FITZSIMONS GATEWAY MULTIFAMILY | SITE PLAN

LOT 2, BLOCK 1 FITZSIMONS PROMENADE SUBDIVISION FILING NO. 1 AMENDMENT 1
 LOCATED IN THE NORTHWEST 1/4 OF SECTION 1, TOWNSHIP 4 SOUTH, RANGE 67 WEST OF THE 6TH P.M.,
 CITY OF AURORA, COUNTY OF ARAPAHOE, STATE OF COLORADO

- 05/17/2023 MA:
 - CURB RAMPS ADDED TO SITE PLAN SHEET TO SHOW ACCESSIBLE TRANSITION FROM ADA PARKING SPACES TO SIDEWALK ON THE EAST SIDE OF THE BUILDING. RESULTING ADJUSTMENTS TO TRANSFORMER PAD LOCATIONS FOR SAFETY OFF-SETS. UPDATES SHOWN ON SITE PLAN, UTILITY & GRADING PLAN, HARDSCAPE PLAN, LANDSCAPE PLAN, LANDSCAPE ENLARGEMENTS, AND OVERALL PHOTOMETRIC PLAN.
 - AMENITY DECK LANDSCAPE PLANTERS AND FENCING REVISED PER COMMENTS RECEIVED DURING BUILDING PERMIT REVIEW. COBBLE REMOVED AND PLANTERS MOVED FURTHER FROM EDGE, FENCING DETAIL REVISED. UPDATES SHOWN ON LANDSCAPE ENLARGEMENTS, LANDSCAPE DETAILS, LEVEL 3 PHOTOMETRIC PLAN.

DATE:
 08/24/2022 - SITE PLAN 01
 10/17/2022 - SITE PLAN 02
 11/23/2022 - SITE PLAN 03
 12/19/2022 - SITE PLAN 04
 02/13/2023 - SITE PLAN 05
 05/17/2023 - MINOR AMD 01

SHEET TITLE:
 LANDSCAPE DETAILS

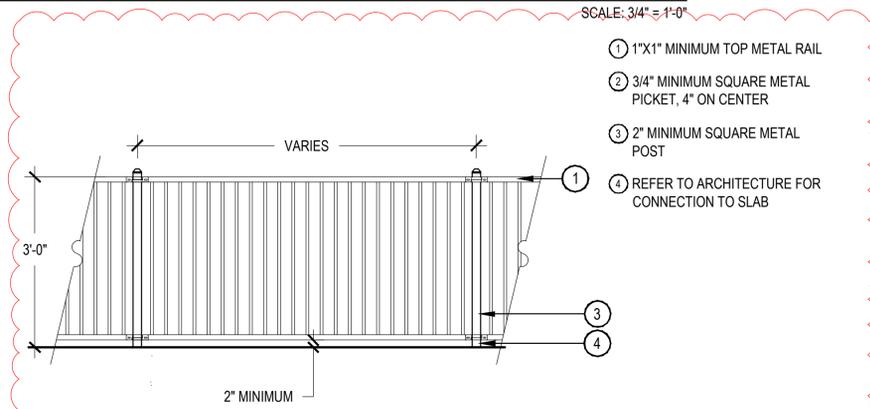
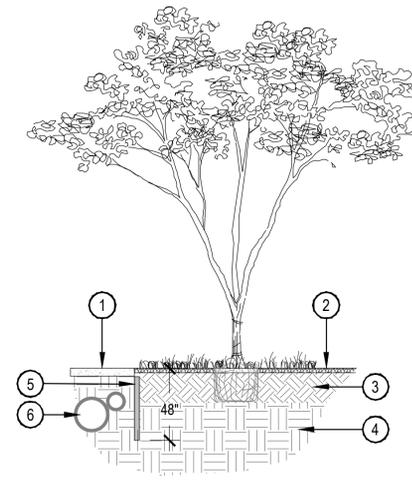
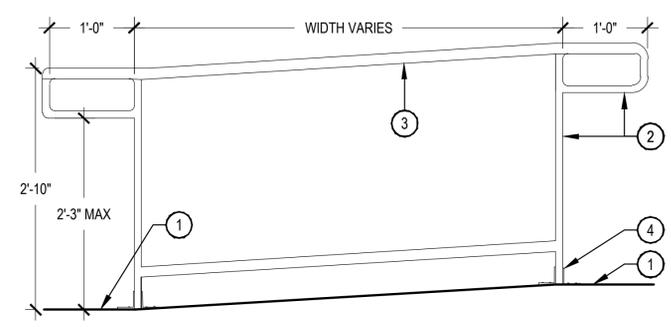
REVISIONS TO BARRIER AND PLANTERS PER BUILDING PERMIT COMMENT

1 SITE LIGHTING PHOTOMETRIC
SCALE: 1" = 30'-0"

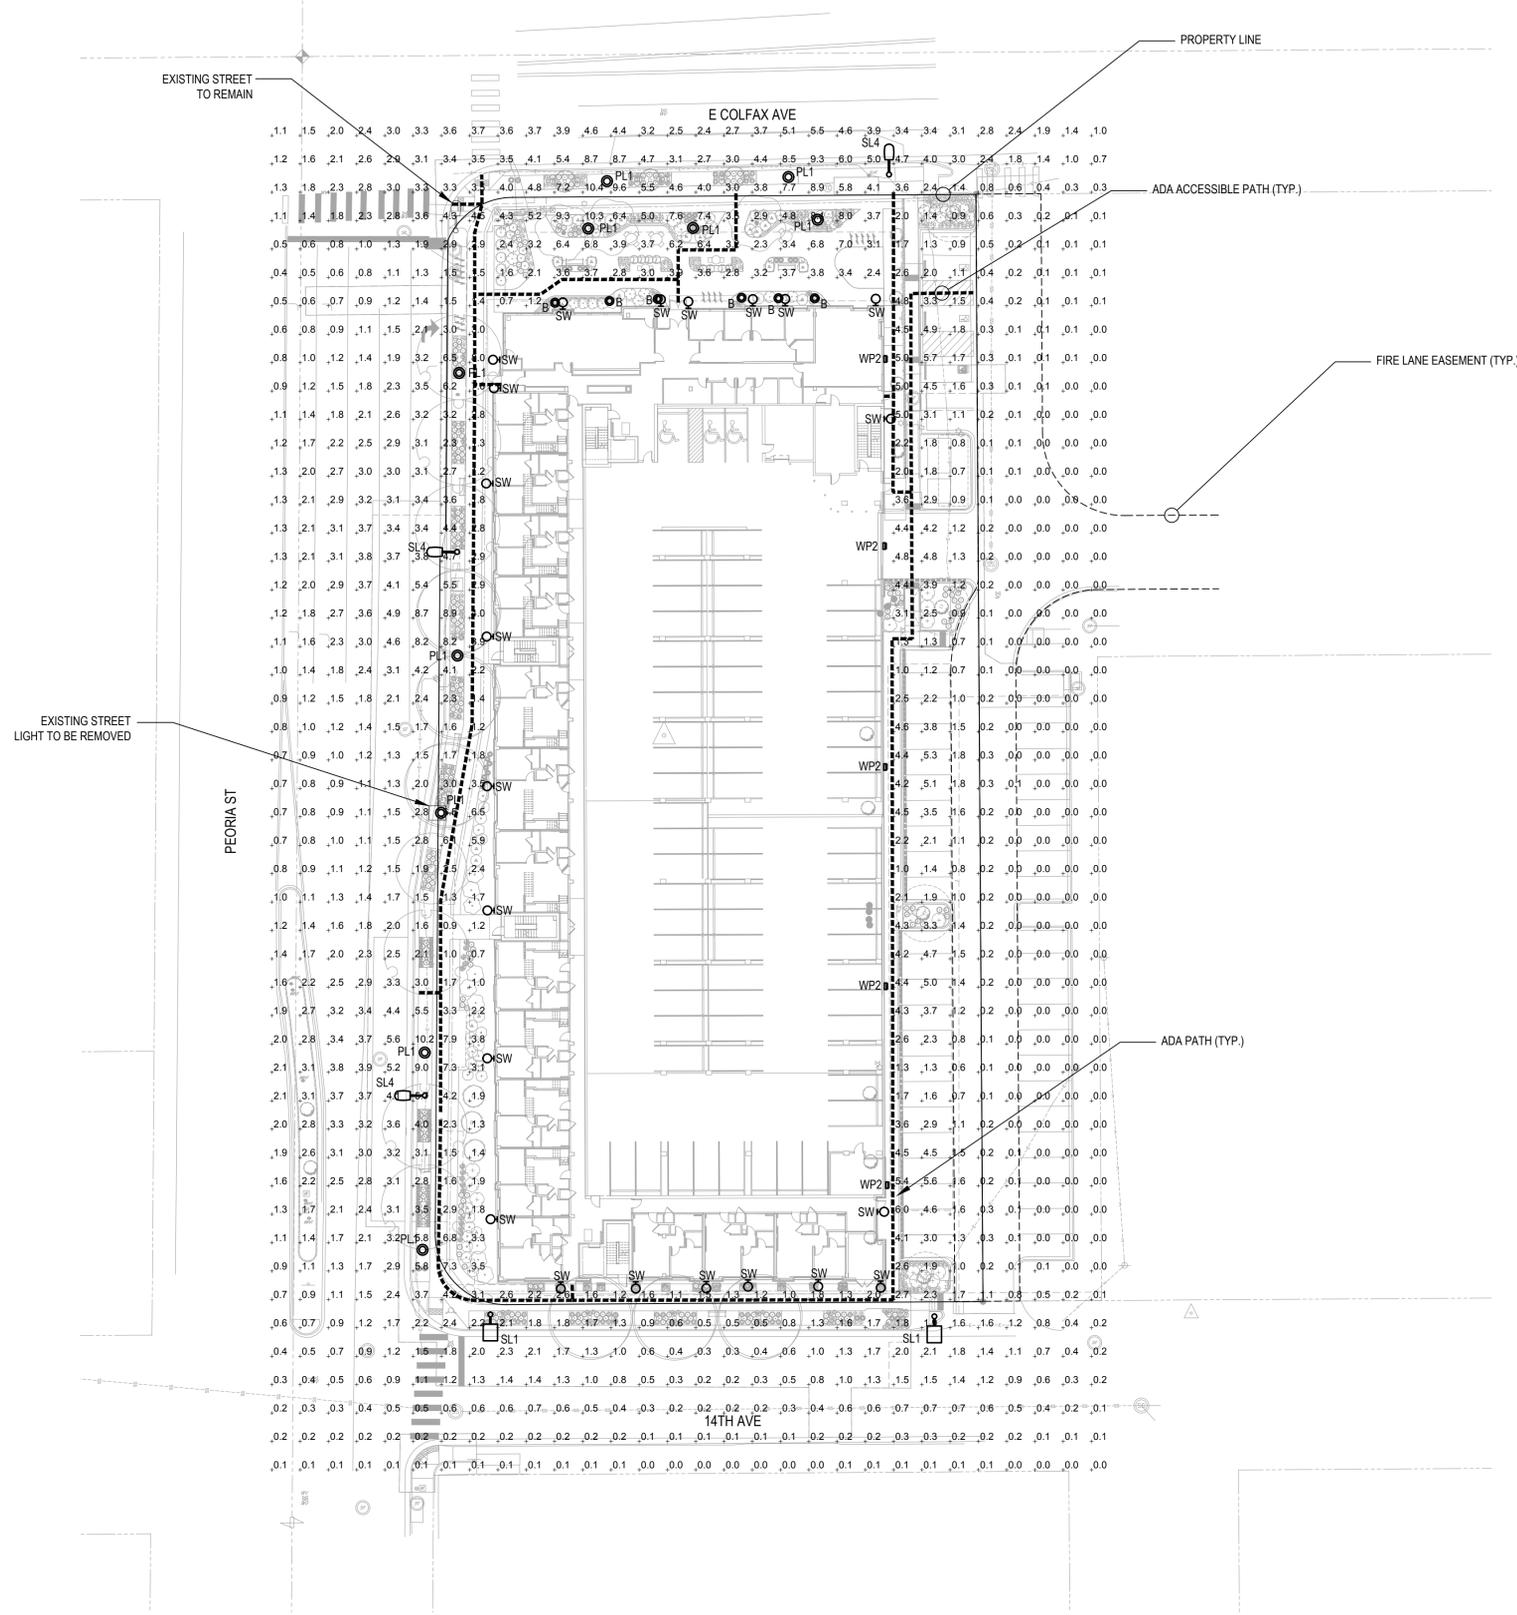
1 LIGHTING PLAN HAS NOT CHANGED, BUT UNDERLYING BASE DRAWINGS UPDATED TO REFLECT CHANGES WITH CIVIL AND LANDSCAPE DRAWINGS

1 LEVEL 3 PHOTOMETRIC
 SCALE: 1" = 30'-0"

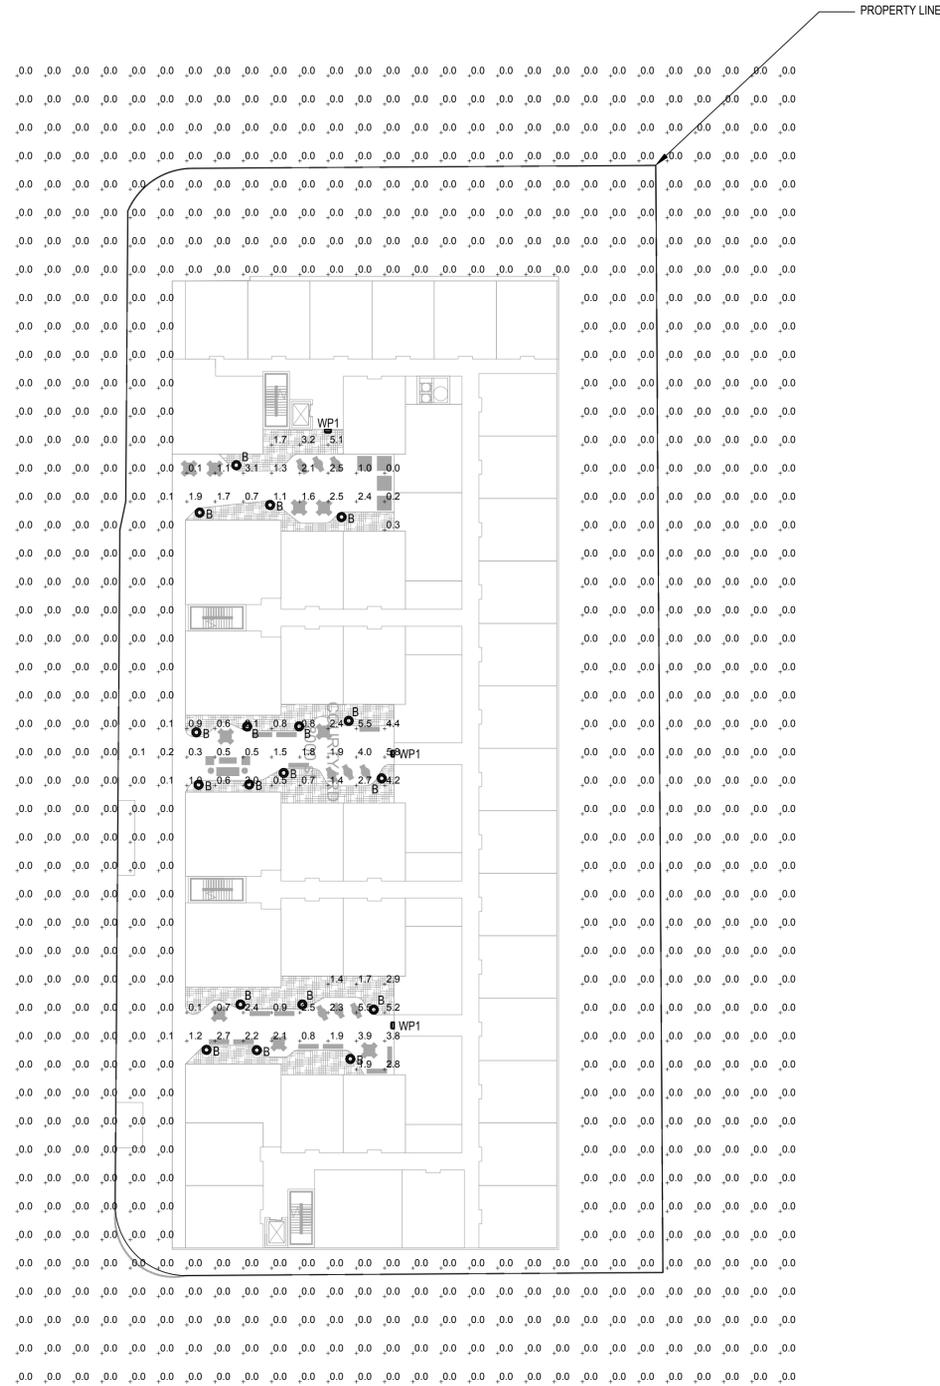
1 LIGHTING PLAN HAS NOT CHANGED, BUT UNDERLYING
 BASE DRAWINGS UPDATED TO REFLECT CHANGES
 WITH CIVIL AND LANDSCAPE DRAWINGS
